HISTORIC AND DESIGN REVIEW COMMISSION

HDRC CASE NO: 2025-090
ADDRESS: 910 E SOUTHCROSS BLVD
LEGAL DESCRIPTION: NCB 7665 LOT SW 200 OF 4 & NE IRR 118.4 OF SW IRR 233. 4 OF C & W IRR 93 OF 15
ZONING: I-1, H
CITY COUNCIL DIST.: 3
DISTRICT: Mission Historic District
APPLICANT: Edward Hernandez/Nirvana Architecture Studio
OWNER: Isarael Ramirez/LIDS CHRISTIAN CENTER INC
TYPE OF WORK: New Construction
APPLICATION RECEIVED: April 09, 2025
60-DAY REVIEW: June 08, 2025
CASE MANAGER: Caitlin Brown-Clancy

REQUEST:

The applicant is requesting conceptual approval to construct a new 10,000 sf building housing an auditorium, classrooms, and various auxiliary spaces on the existing campus of LIDS Christian Center at 910 E Southcross Blvd and site work consisting of a master parking plan.

1 SITE PLAN

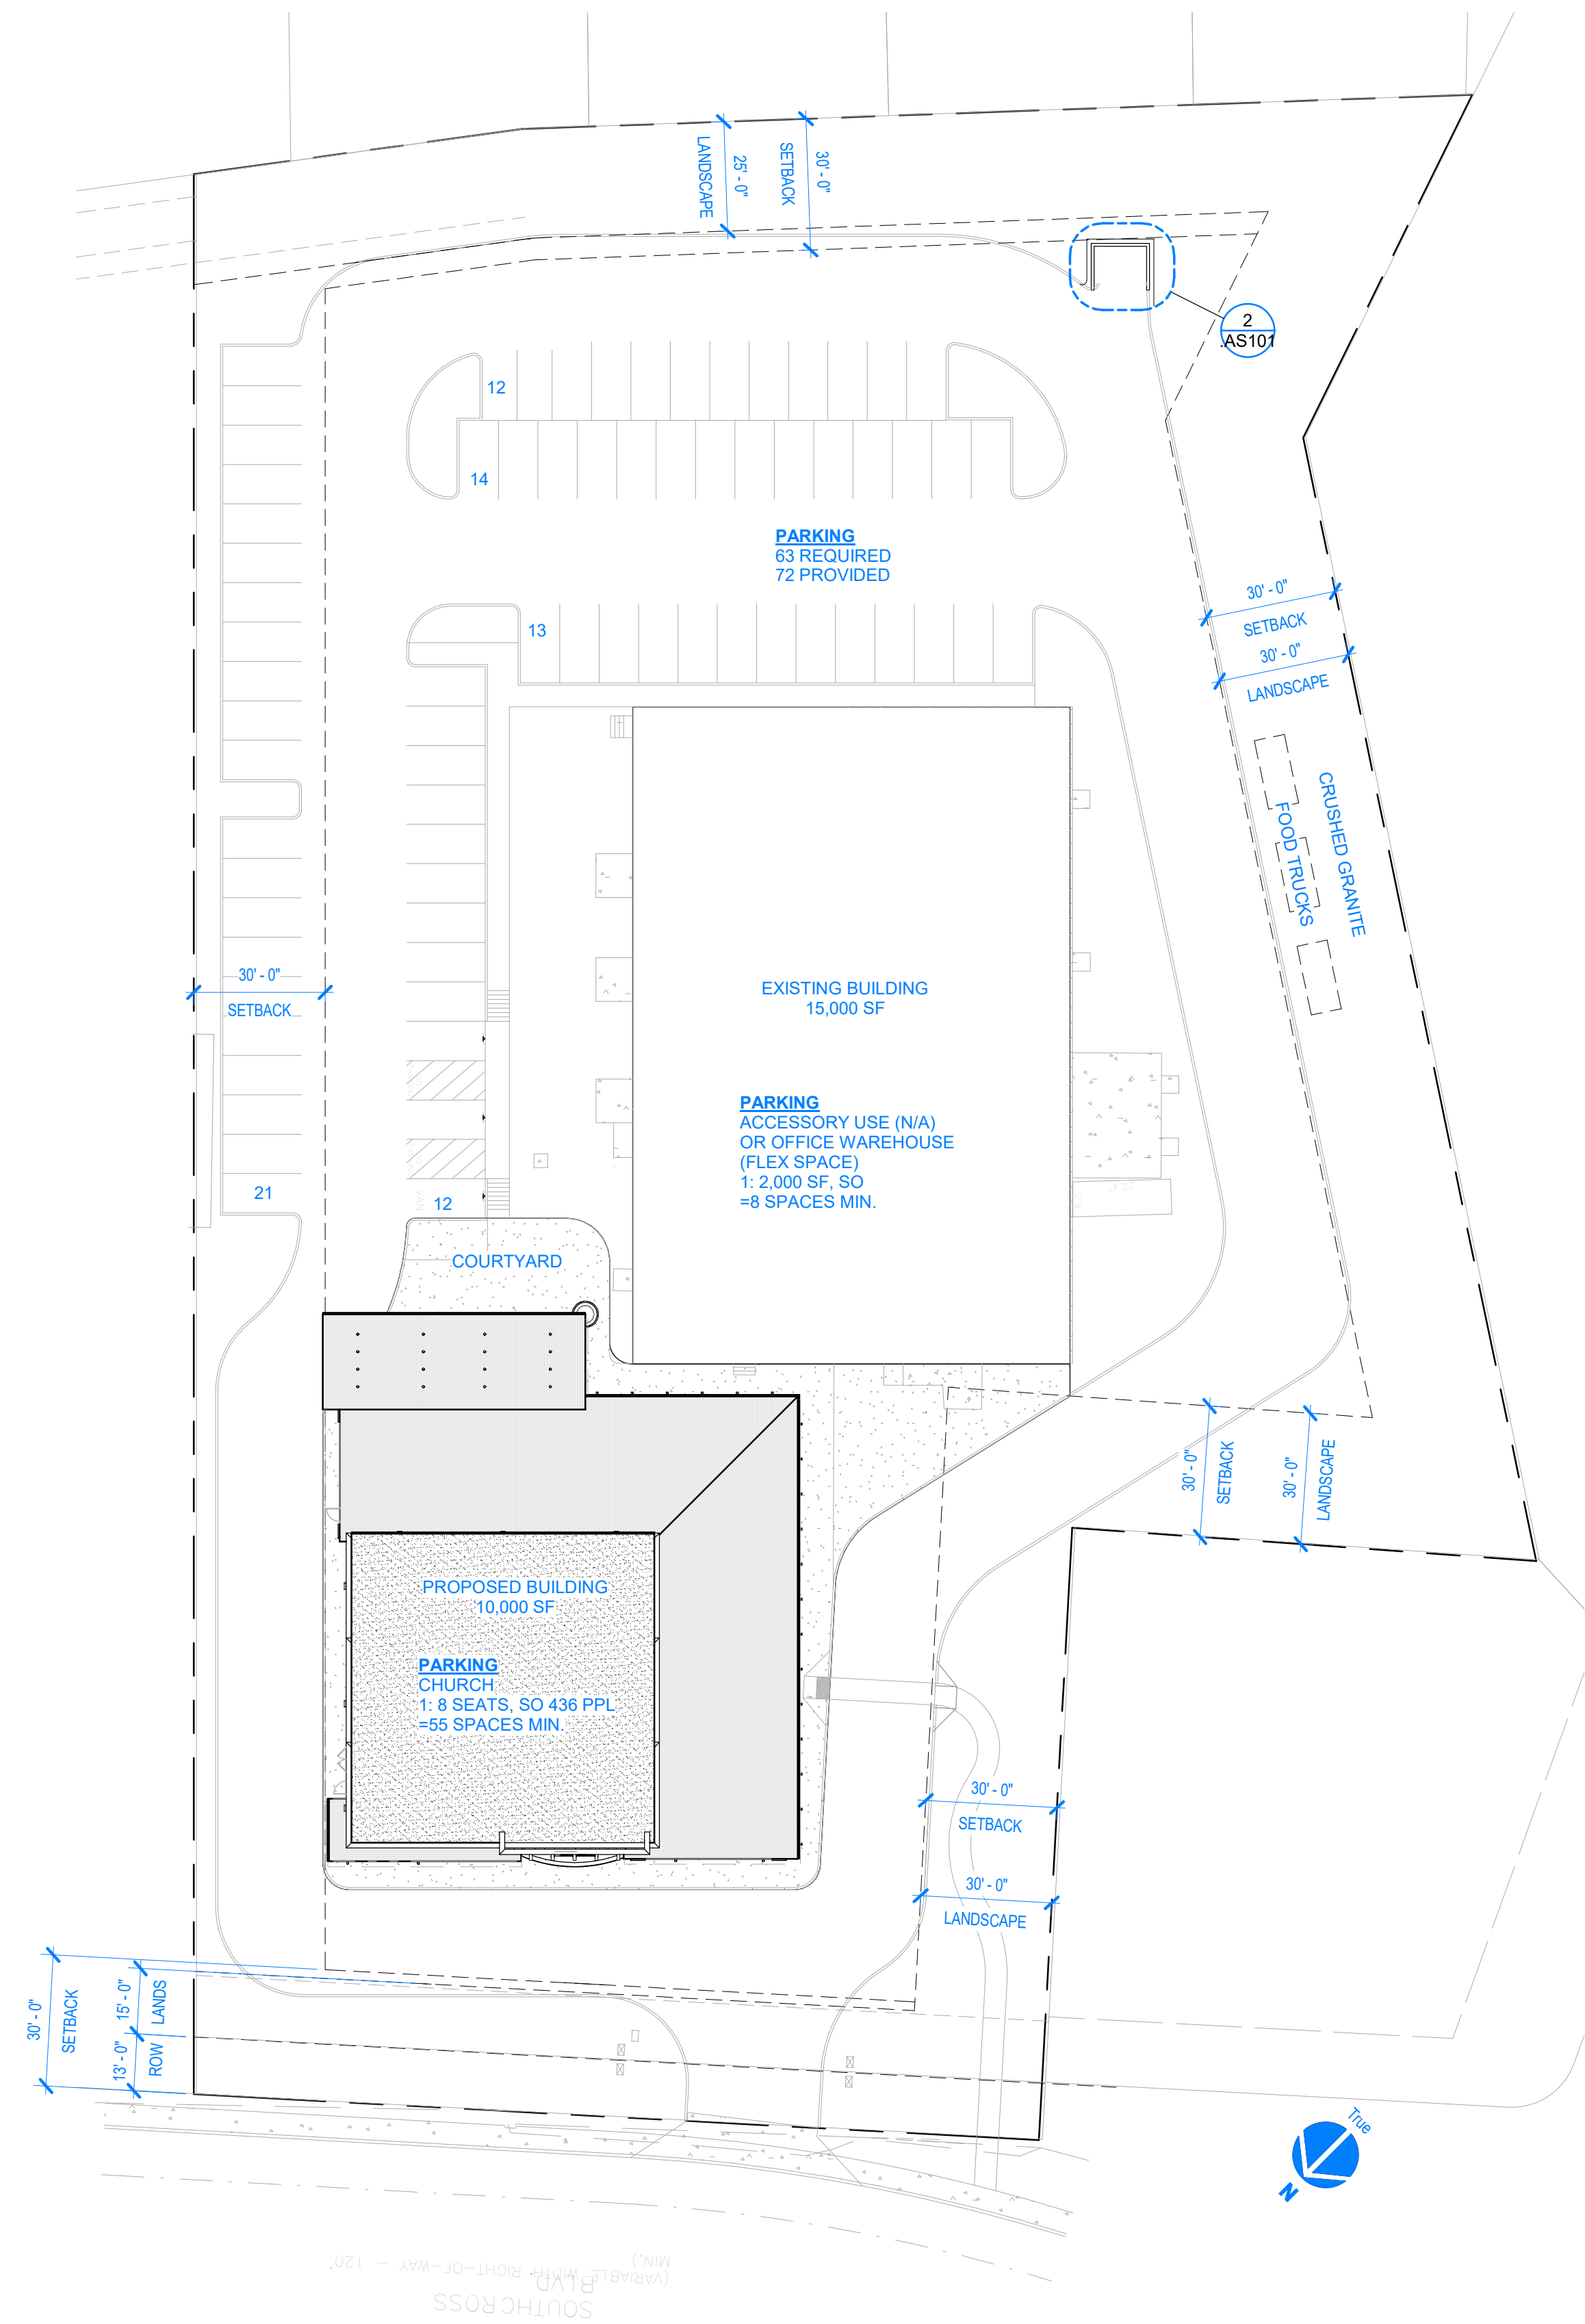
- e. **SITE DEVELOPMENT (SETBACK)** – The applicant has not indicated the exact setback depth, however, plans indicate a set back of approx. 60'0". Guideline 3.A.v states that on corridors where building setbacks vary or are not well-defined by existing contributing buildings, buildings should maintain a minimum front setback of 15' for properties north of SE Military. Staff finds the applicant should submit a dimensioned site plan indicating all setbacks prior to returning to the HRDC for final approval.

- f. **SITE DEVELOPMENT (PARKING)** – The applicant is requesting to introduce parking at the rear and Eastern side of the lot which accommodates 72 spaces. Guideline 3.A.vi states that Rear / side parking is encouraged north of SE Military Drive. Staff find the proposed parking plan appropriate.

- g. **SITE DEVELOPMENT (VEHICULAR ACCESS)** – The applicant has proposed one main driveway into the property that splits into two that circumnavigate the existing and new structures leading to the rear parking lot. Currently, the applicant has not indicated the width of the proposed drive and approach. Guideline 3.A.vii states that, in general, driveway widths should not exceed 24'. Staff finds the applicant should submit a dimensioned site plan indicating driveway and approach dimensions prior to returning to the HRDC for final approval.

1. That the applicant submit an accurately scaled and dimensioned site plan indicating all necessary setbacks, driveways and other significant site elements as necessary for review prior to returning to the HDRC for final approval based on findings a, c, and g.
2. That the applicant submit all material specifications to include all siding materials, roofing materials and fenestration products for review prior to returning to the HDRC for final approval based on findings a, j and l.
3. That the applicant submit a detailed landscaping plan indicating location and type of plantings and materials to be used for review prior to returning to the HDRC for final approval based on findings a and m.
4. That an archaeological investigation is conducted. The project shall comply with all federal, state, and local laws, rules, and regulations regarding archaeology, as applicable.

EXTERIOR ELEVATIONS

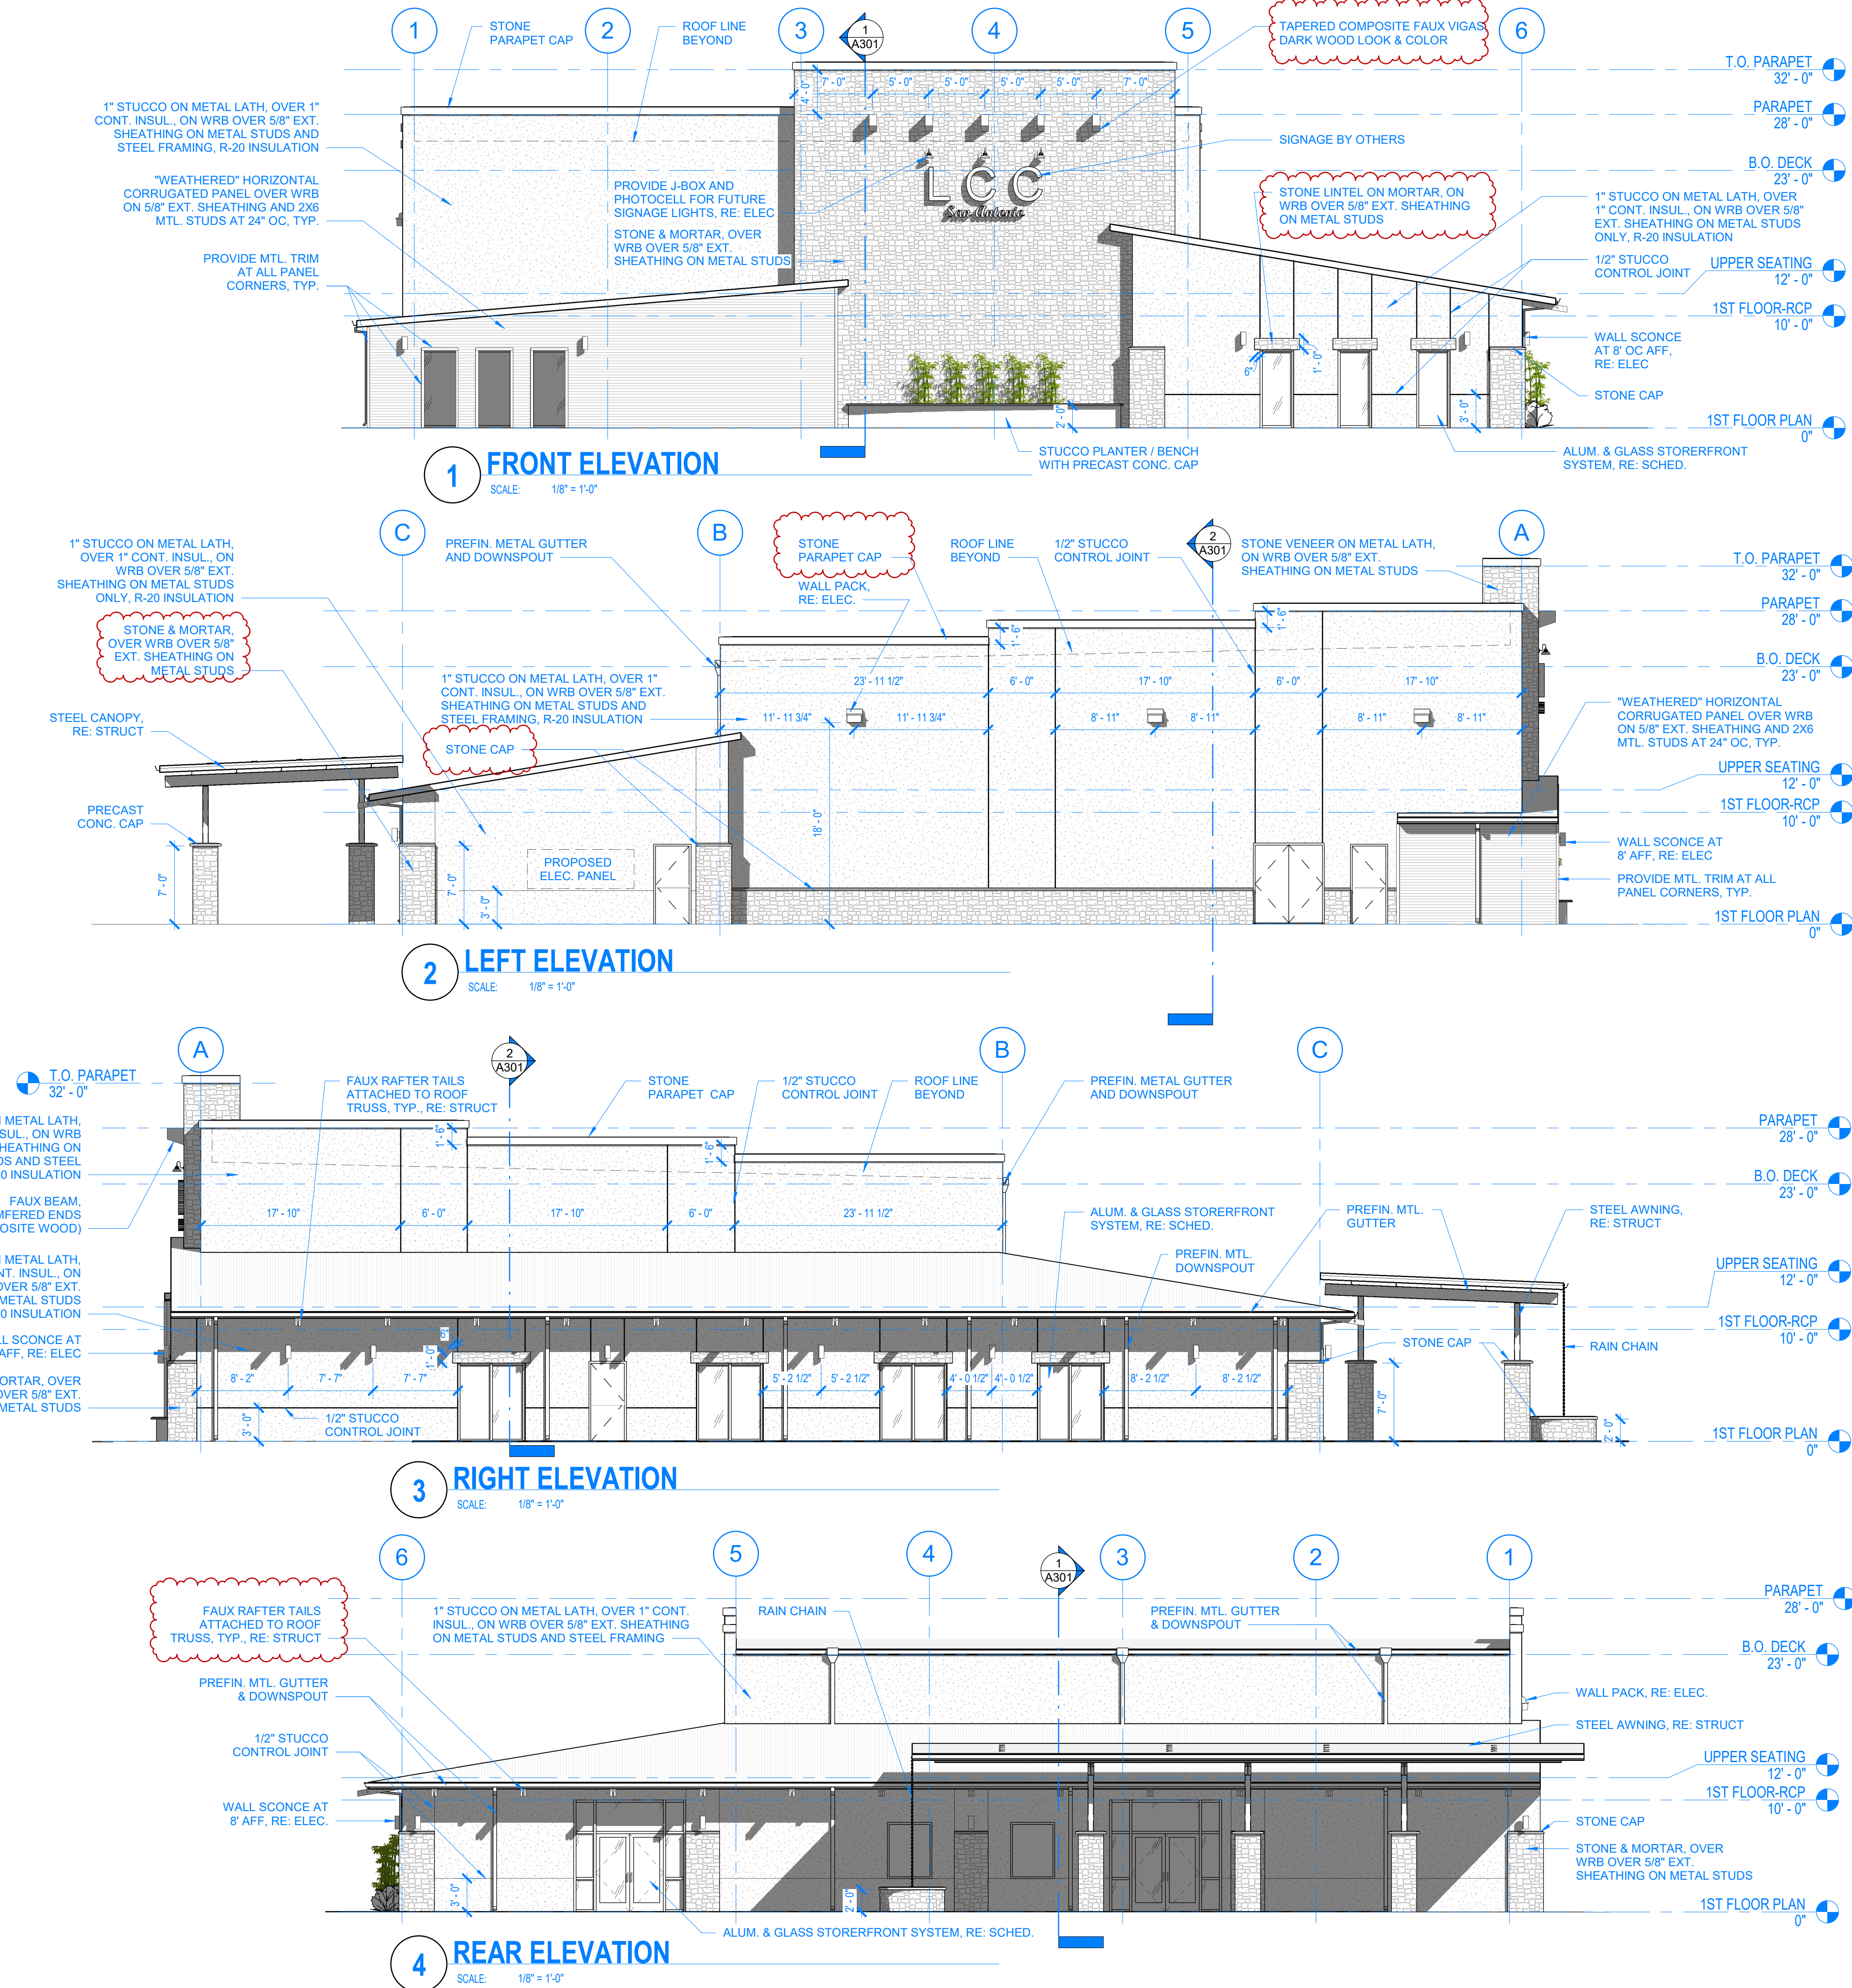
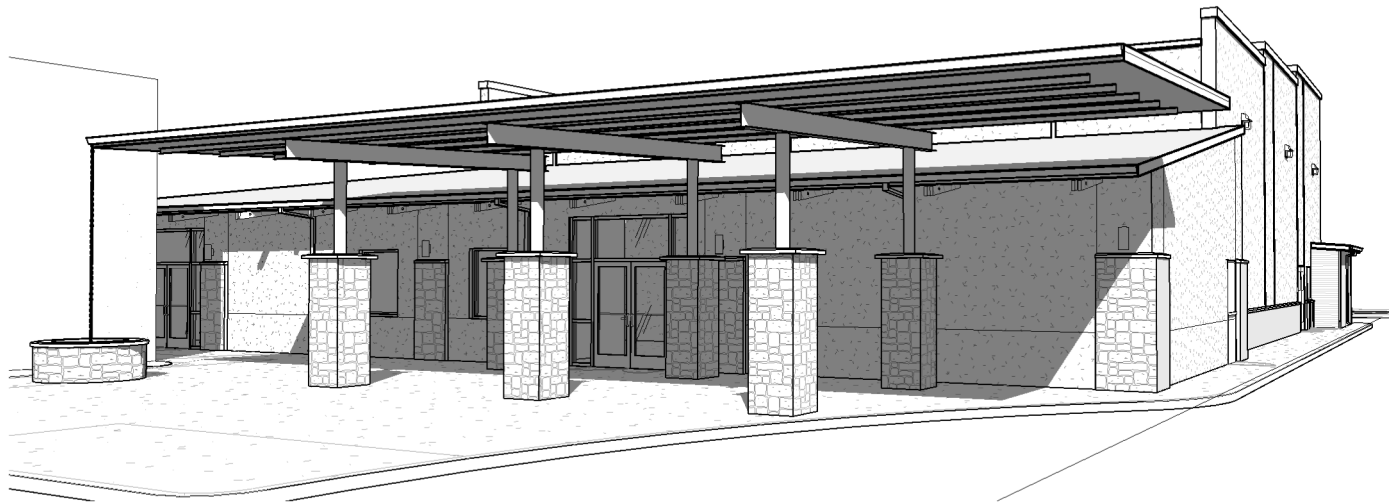
- h. **MASS, SCALE, FORM** – The applicant is requesting to construct a building whose primary façade features a hierarchical, massive, central form flanked by a secondary form to the West and a tertiary form to the East. The design calls for a transition in height of 32'0" at the highest roof projection of the ROW façade to 18'0" at the rear façade. The applicant utilizes transitions, material changes, and surface reliefs/control joints to provide interest to an otherwise monolithic expanse. Guideline 3.B.i states that Wall planes and fenestration patterns should be organized to yield facades that appear monolithic and enduring while still allowing for visual interest through breaks in scale and pattern. Staff finds the proposed form and mass consistent with the Guidelines particularly given the language of the adjacent structures to the property.

- i. **ROOF FORM** – The applicant has proposed a primary form consisting of a flat roof with a parapet wall punctuated by a taller parapet which projects 4'0" above the aforementioned flat roof with parapet. This central form is flanked on either side by a secondary form to the West and a tertiary form to the East both of which feature a shed roof form. Guidelines 3.C.i and ii state that a flat roof with a parapet wall is recommended as a primary roof form for all commercial buildings. Parapets may vary in height to articulate individual wall planes or programmatic elements such as entrances. Additionally, secondary roofs should utilize traditional forms such as a hip or gable and should establish a uniform language that is subordinate to the primary roof form. Contemporary shed roofs may be considered on a case-by-case basis as a secondary roof form based on the design merit of the overall proposal and the context of the site. Staff finds the proposed roof forms consistent with the Guidelines.

- j. **MATERIALS** – The applicant has proposed to use a combination of traditional and non-traditional materials to include (in descending order of scale of application) stucco, stone, and corrugated metal. Guidelines define traditional materials as regionally-sourced stone, wood, and stucco. Guideline 3.D.iii specifically indicates that, a minimum of 75% of the exterior facades should consist of these materials while a maximum of 25% of the exterior facades should consist of non-traditional materials. The applicant has proposed two possible finish options for the corrugated material used as a siding material on the Eastern tertiary form as well as the roof material of the secondary form of the Western façade. One option is a standard galvalume finish and the other a rusted Corten appearance. Staff finds the rusted Corten appearance to be a more appropriate choice. Staff finds the applicant should submit all material specifications for review prior to returning to the HDRC for final approval.

- l. **WINDOWS** – At this time, the applicant has not submitted exact window specifications. The drawing indicate use of a typical storefront fenestration system on the primary, rear and Western facades. Staff finds the applicant should install windows that meet the Standard Specifications for Windows in New Construction and that the applicant should submit product specifications for review prior to returning the HDRC for final approval.

Savino – Generally improved, arched windows perhaps not necessary but something with divided lites to reference human scale, perhaps wrap the corrugated panel along the left elevation, start working through some of those details

Fetzer – Headed in the right direction, much improved, does not need to be so literal with the arched windows, think of the windows like you’ve considered the modern take of the rafter tails, left side needs some additional help with the massing, break it up with a control joint?, either raise or lower the stone veneer to the height of the doors or lower to not compete, consider where you’ve placed your control joints, the roof of the outdoor porch area roof might be better sloped in the parallel sense, not the

Garza - agrees that perhaps the arched windows aren’t necessary, play with the parapet a bit, stone caps as flashing vs. metal, consider how to break up massing of the left elevation a bit further
